TECHNICAL SERVICE BULLETIN

Loss Of Engine Coolant And/Or Cooling Fan Noise

26-2060

Ford	3.5L EcoBoost
2026 Transit	3.5L Duratec

Figure 1

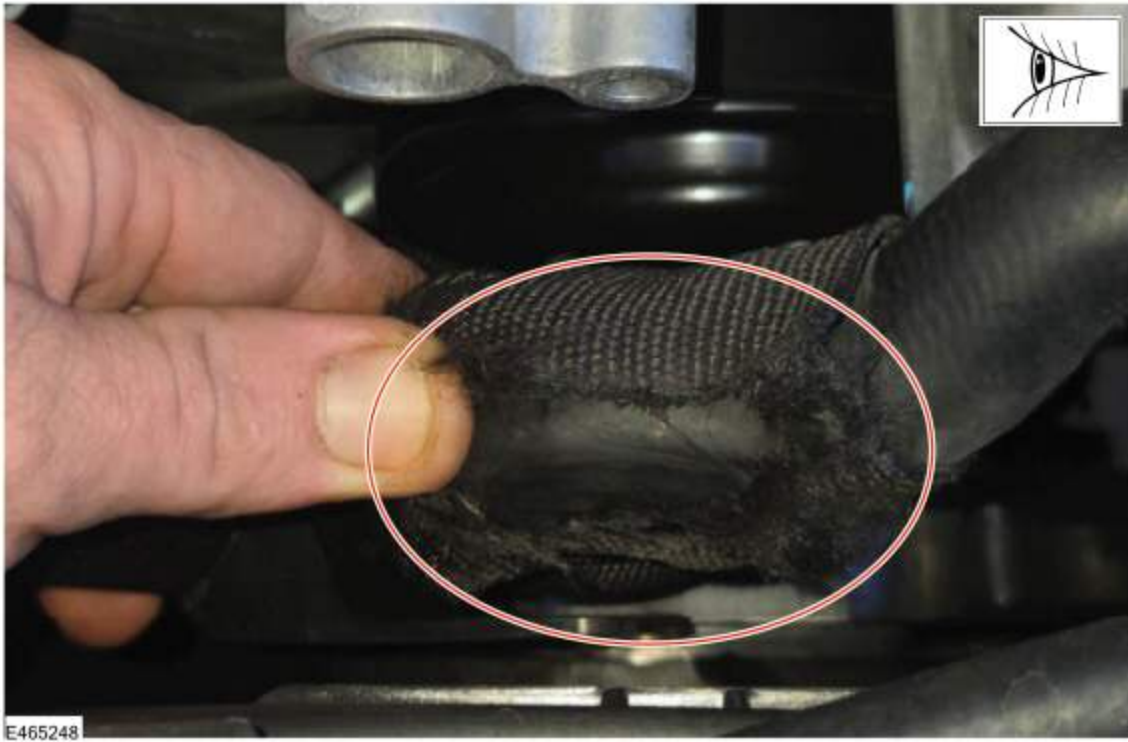
Issue: Some of the vehicles listed in the Model statement above may exhibit a loss of engine coolant at the heater hose assembly near the engine cooling fan. The vehicle may also have DTCs P1299 and/or P1285 stored in the PCM. This may be due to an incorrectly indexed hose connection at the thermostat housing causing contact with the cooling fan.

1. Visually inspect the coolant heater hose assembly near the cooling fan assembly for leaks and damage (Figures 1-2). Is damage or coolant leakage present?

Action: For vehicles that meet all of the criteria in the Issue and Model statements, follow the Service Procedure to replace and correctly index the coolant heater hose assembly and if necessary, inspect and replace the cooling fan motor and shroud assembly.

Figure 3

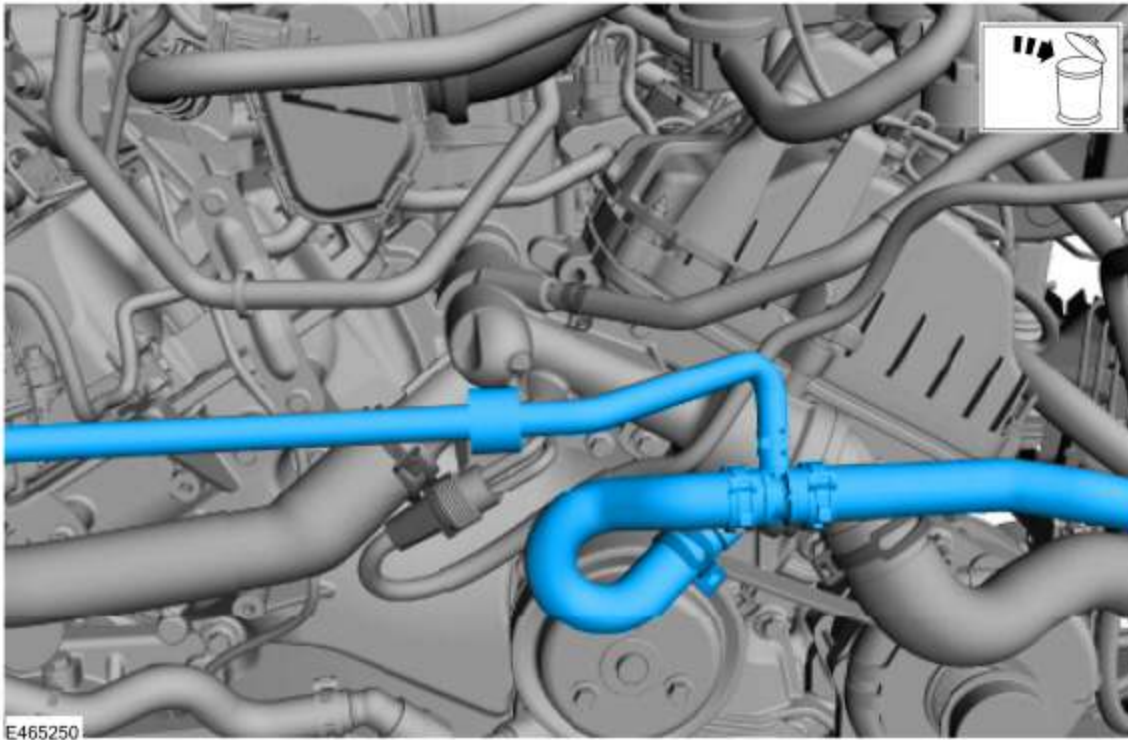
2. Inspect the cooling fan blades for damage due to contact with the heater hose (Figure 3). Is any damage present?

1. Yes - proceed to Step 3.
 2. No - proceed to Step 4.
 3. Replace the cooling fan motor and shroud assembly. Refer to the WSM, Section 303-03 Engine Cooling > Removal and Installation > Cooling Fan Motor and Shroud.
 4. Drain the cooling system. Refer to the WSM, Section 303-03 Engine Cooling > General Procedures > Engine Cooling System Draining, Vacuum Filling and Bleeding.
 5. Remove and discard the heater hose (Figure 4).
- Figure 4 - Heater hose 3.5L Duratec shown, 3.5L EcoBoost similar
